Northern interchange compound (C9)

9.4.2 Environmental overview of changes

9.5 Additional construction use at the Junction Road compound (C11)

Figure 9-19 Northern interchange compound access arrangement C9-1

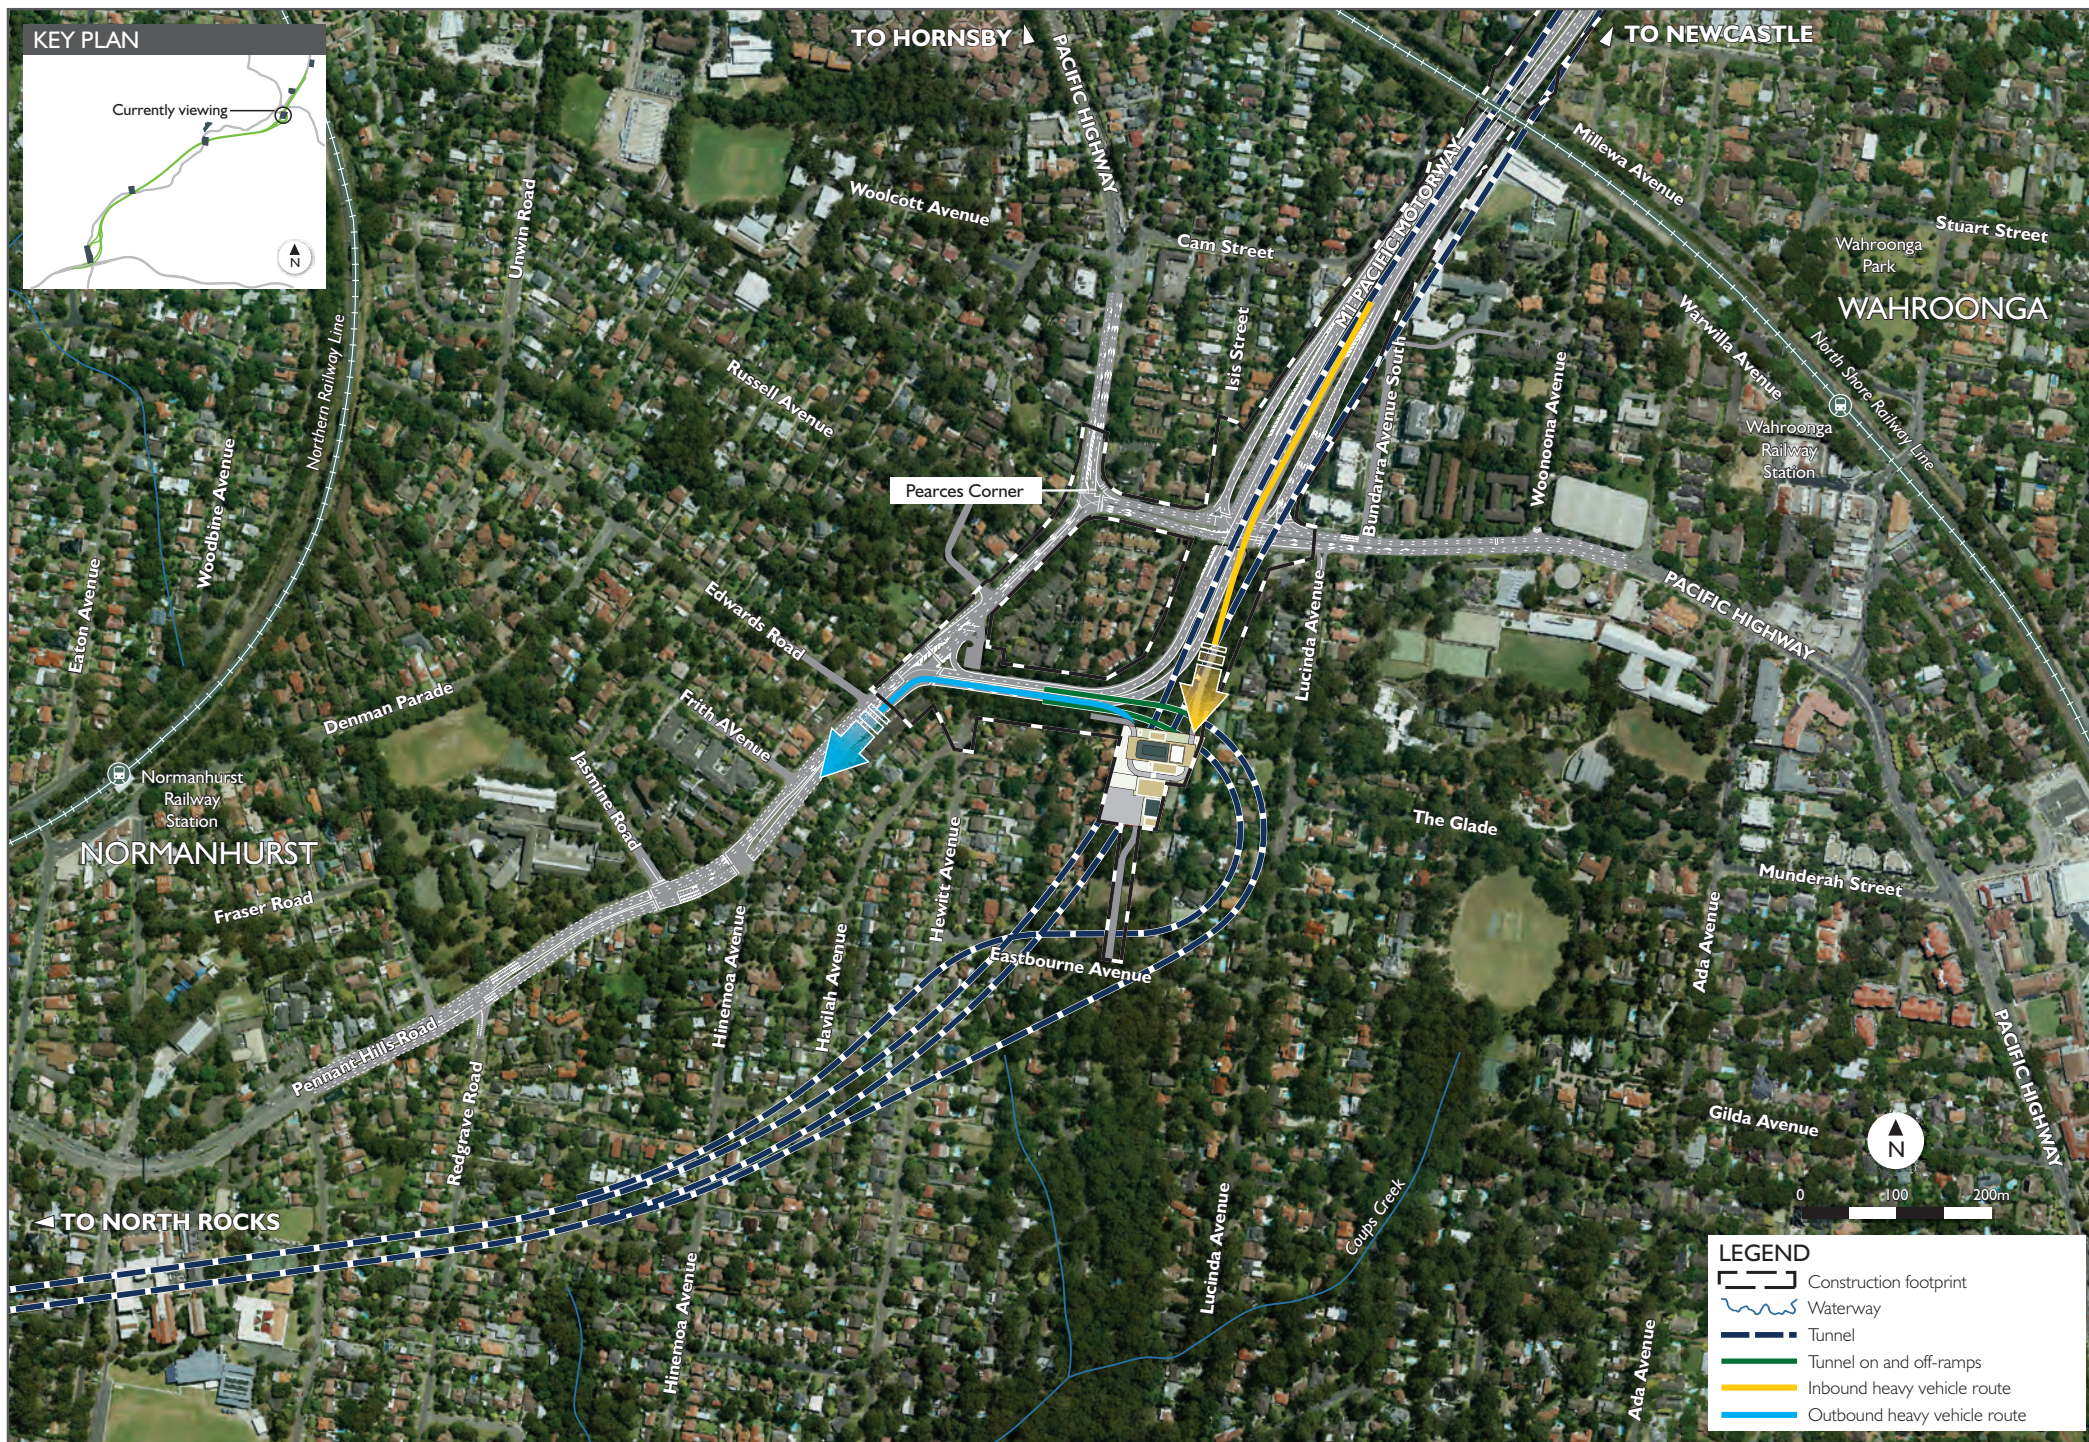
Access arrangement C9-1 involves the same arrangement as identified in the environmental impact statement. This arrangement is reproduced here for completeness and avoidance of potential confusion. Heavy vehicles travelling to a southern / western spoil disposal site would continue along Pennant Hills Road to the Hills M2 Motorway. Heavy vehicles travelling to a northern spoil disposal site would be able to turn around at Beecroft Road (around Observatory Park) to travel north along Pennant Hills Road to the M1 Pacific Motorway. This access arrangement is shown on **Figure 9-19**.

Figure 9-20 Northern interchange compound access arrangement C9-2

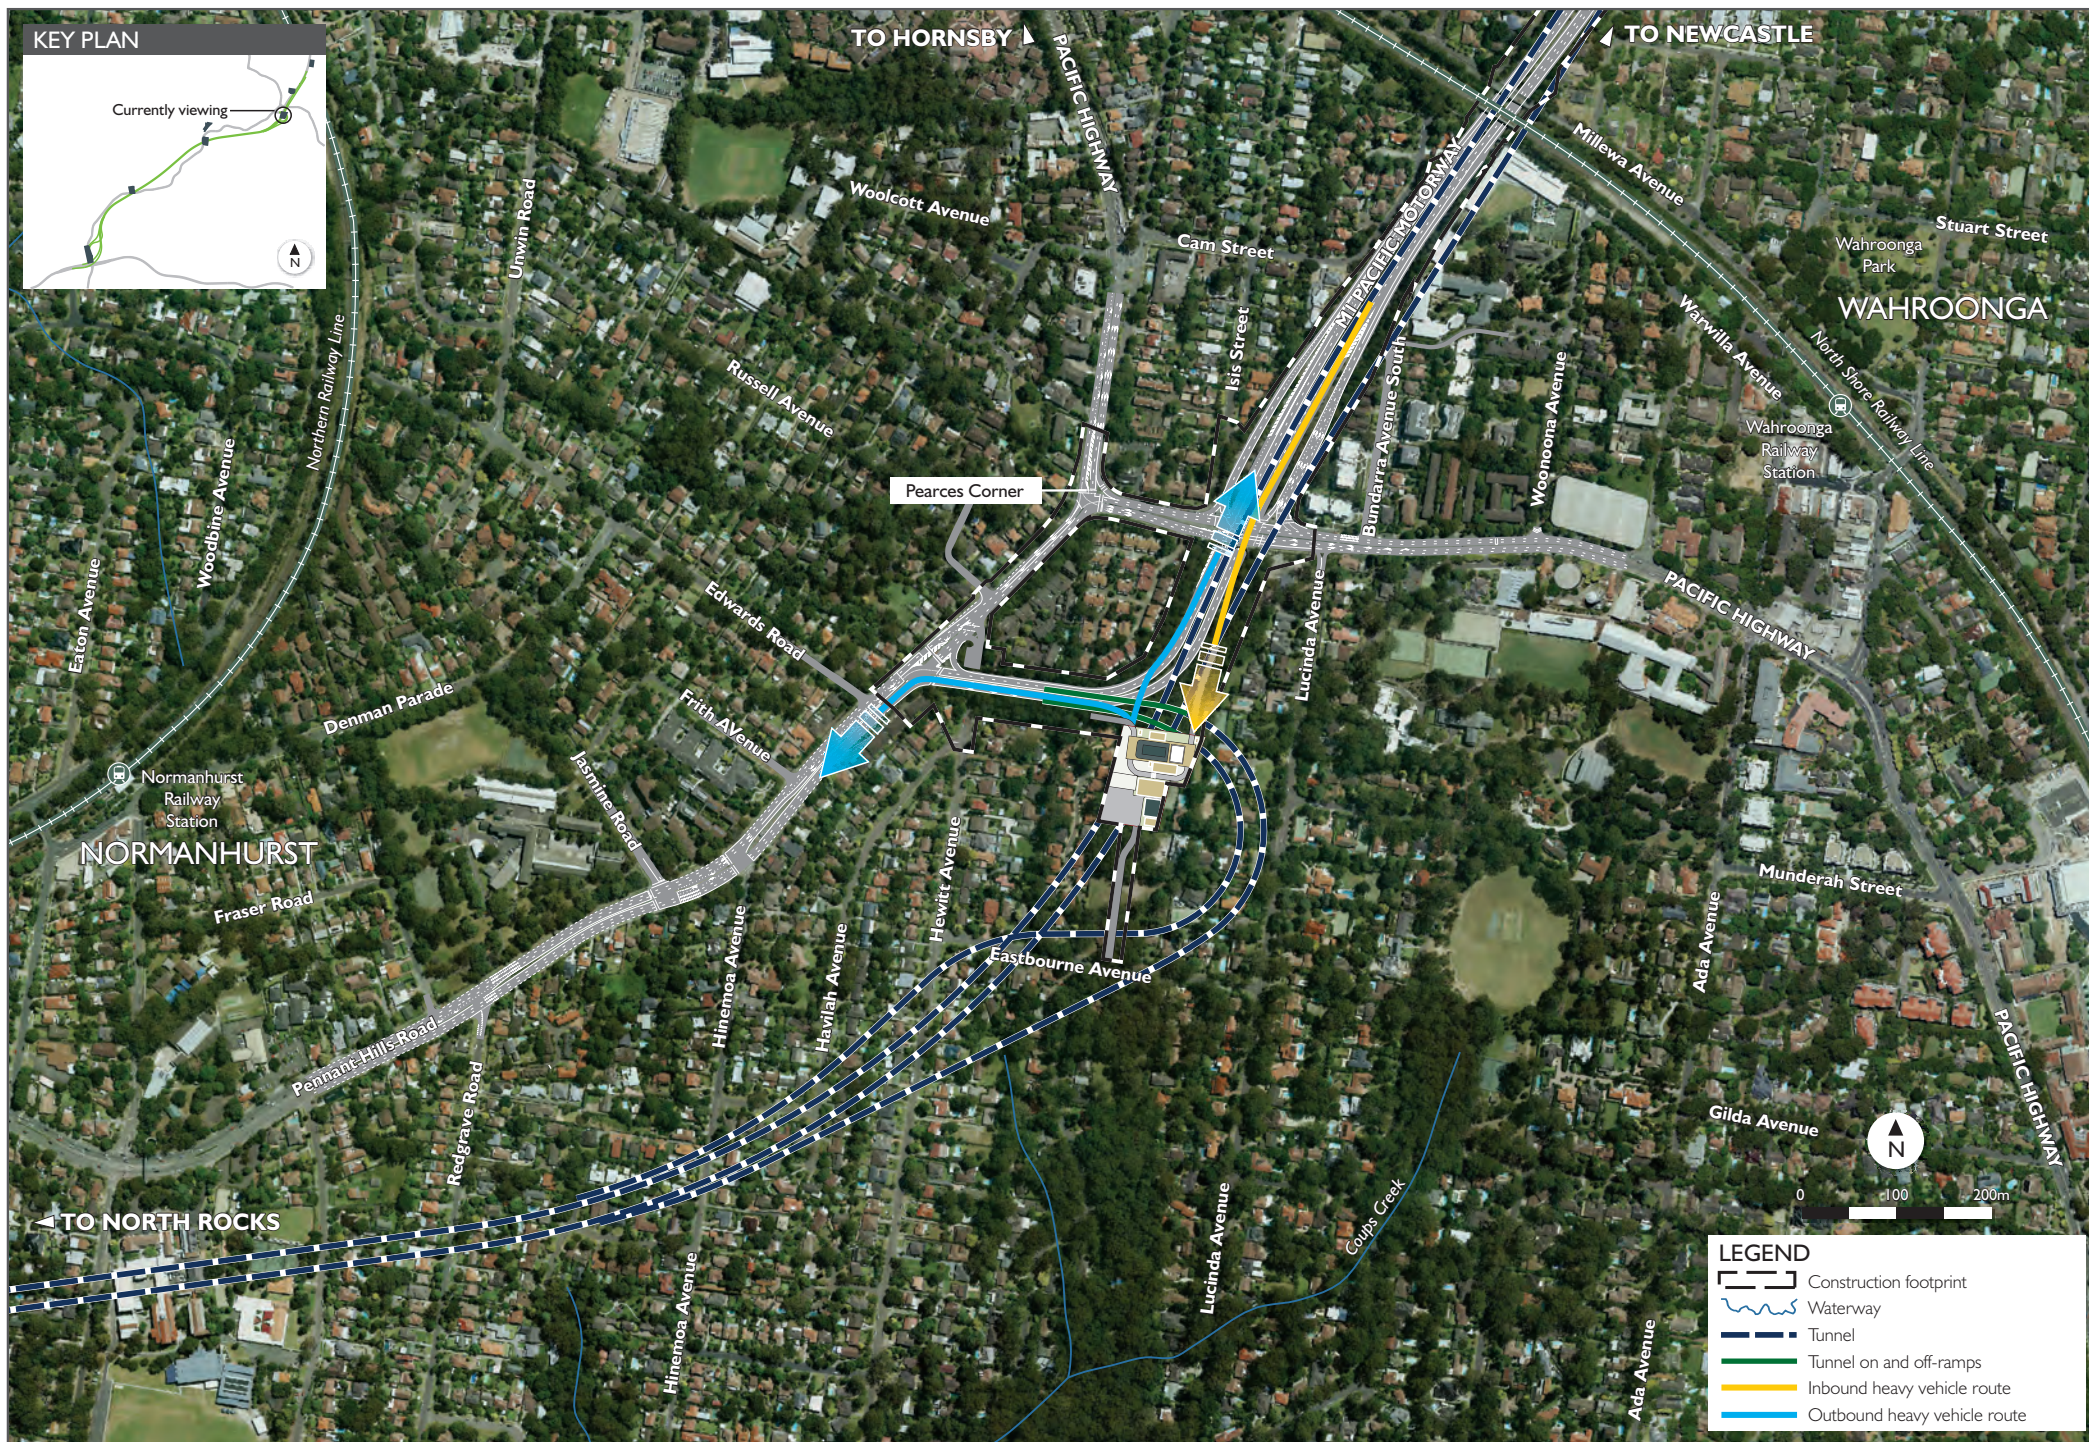
Access arrangement C9-2 involves a left in, left out, right out access to and from the M1 Pacific Motorway at a new temporary signalised intersection. This new signalised intersection would stop southbound traffic on the M1 Pacific Motorway to allow heavy vehicles to egress the site. Heavy vehicles travelling to a southern / western spoil disposal site would continue along Pennant Hills Road to the Hills M2 Motorway. Heavy vehicles travelling to a northern spoil disposal site would be able to turn right out of the site directly onto the M1 Pacific Motorway to travel north. This access arrangement is shown on **Figure 9-20**.

Northern interchange access arrangement C9-2

The introduction of a new signalised construction access on the M1 Pacific Motorway around 180 metres to the east of the Pennant Hills Road / M1 Pacific Motorway intersection would result in a slight improvement in the local road network. Under this proposed arrangement, construction vehicles egressing the compound that are travelling to a northern spoil site would no longer require the use of the Beecroft Road u-turn and would be removed from the Pennant Hills Road corridor. Hence, the intersections from the M1 Pacific Motorway to Beecroft Road (south) would improve slightly when compared to the assessment presented in environmental impact statement.

Due to relatively low construction traffic demands and subsequent short green time required, the new signalised intersection would operate with low delay at LoS A in both peaks. However, during the AM peak, queuing on the eastern approach of the downstream intersection of M1 Pacific Motorway / Pennant Hills Road is predicted to be on the threshold of impeding on this new construction access. This queuing combined with the curved nature of the approach emphasises the need for appropriate construction traffic management and control to be developed and implemented in consultation with the Transport Management Centre. This may include measures such as 'advanced signal warnings' and 'queuing ahead' signage along the M1 Pacific Motorway to safely cater for this construction access.
